Service Bulletin	
	Flight Design GmbH Sielminger Str. 51 D-70771 L.-Echterdingen Tel.: +49(0)7021 80460-0 Fax: +49(0)7021 80460-69 E-Mail: airworthiness@flightdesign.com	SB-ASTM-CTSW-10 Revision 01
	Date of Initial Publication: 19-Jul-2012 Publication Date of this Revision: 30-Jul-2012

Inspection of the Rescue System Rear Harness Connection SB-ASTM-CTSW-10

Fig. 2

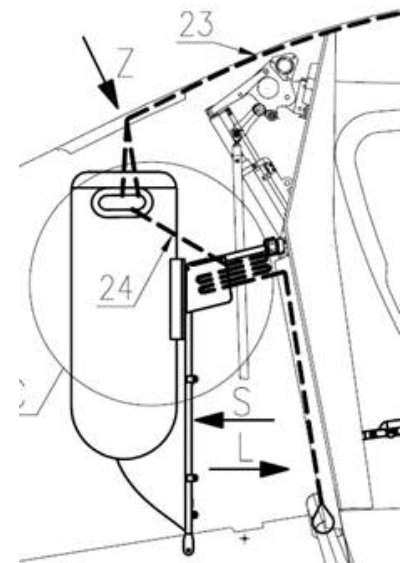
- The harness is routed upwards along the rear side of the main bulkhead, along the right side (in direction of flight) support tube of the parachute bracket towards the parachute canister, where it is connected together with the front harness belts to the quick link that is stowed at the right upper side of the parachute canister – see Fig. 2.

Chapter 3.1: detail reference in [1] changed, routing description of the rear harness updated, Fig.2 is changed, Fig. 3 is added.
